## SUNDRY NOTICES AND REPORTS ON WELLS

7. If Unit or CA/Agreement, Name and/or No.  
SRM11738. Well Name and No.  
GRYNBERG 11 FED COM 49. API Well No.  
30-015-34197-00-S110. Field and Pool or Exploratory Area  
WHITE CITY-WOLFCAMP11. County or Parish, State  
EDDY COUNTY, NM

CIMAREX ENERGY COMPANY OF CO

Gryenberg 11 Federal #4

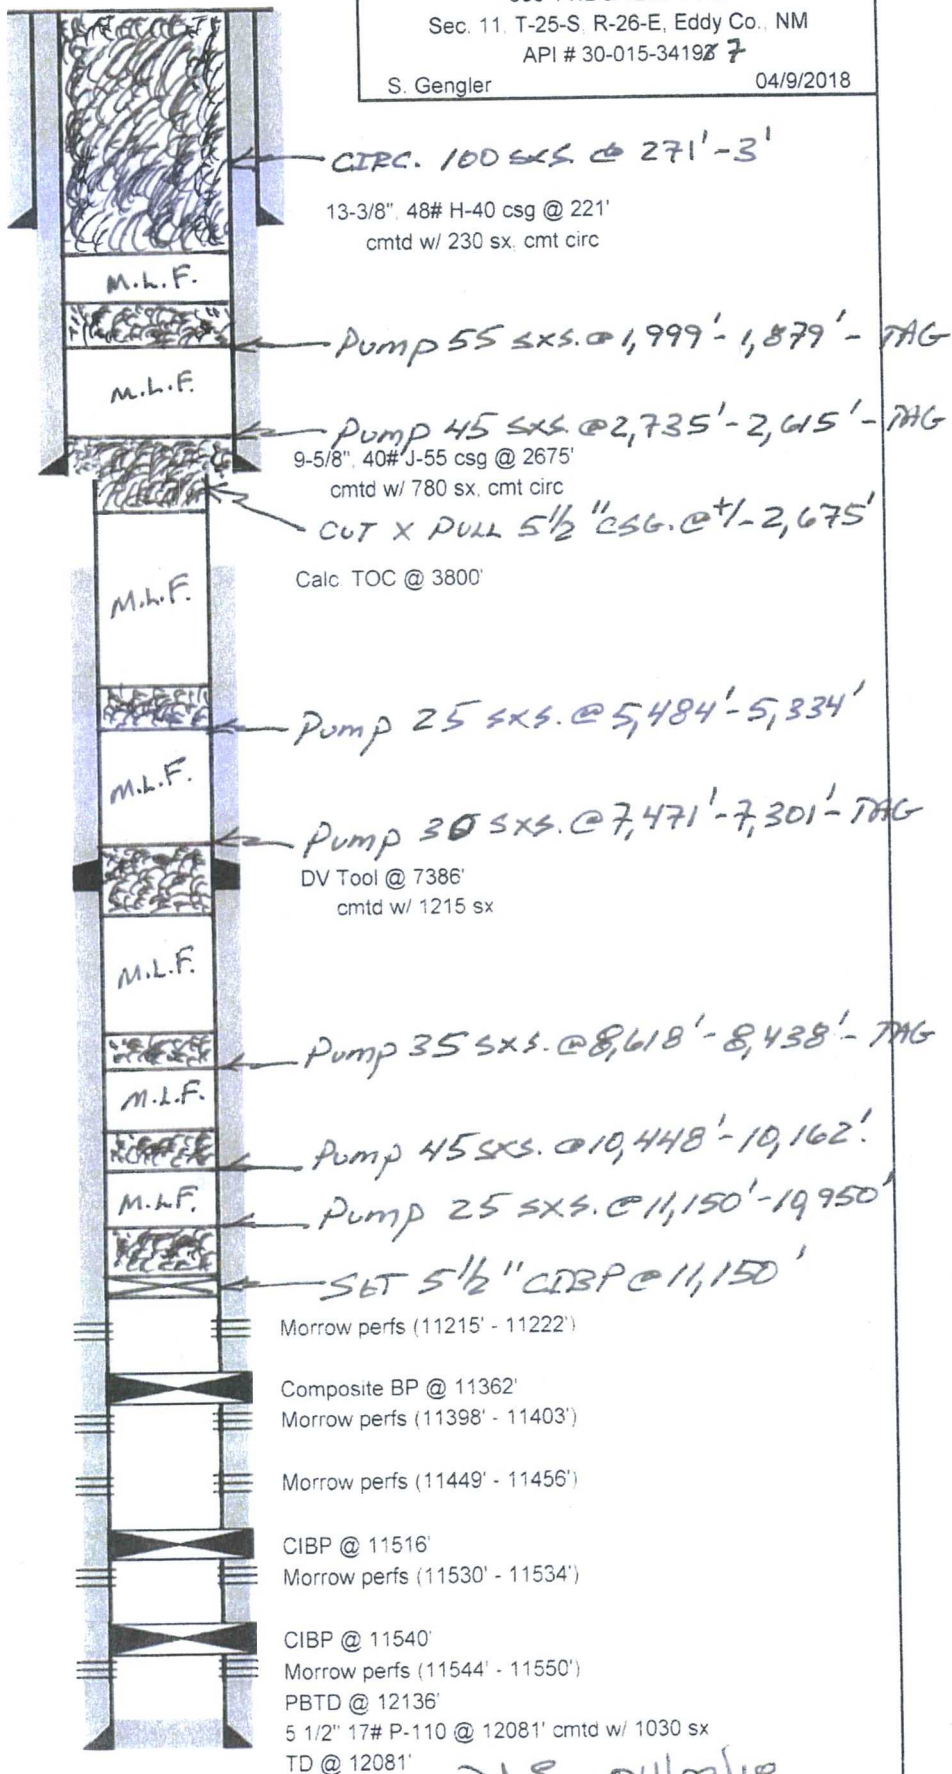
Perf, attenti to SO2.

2775

Standard
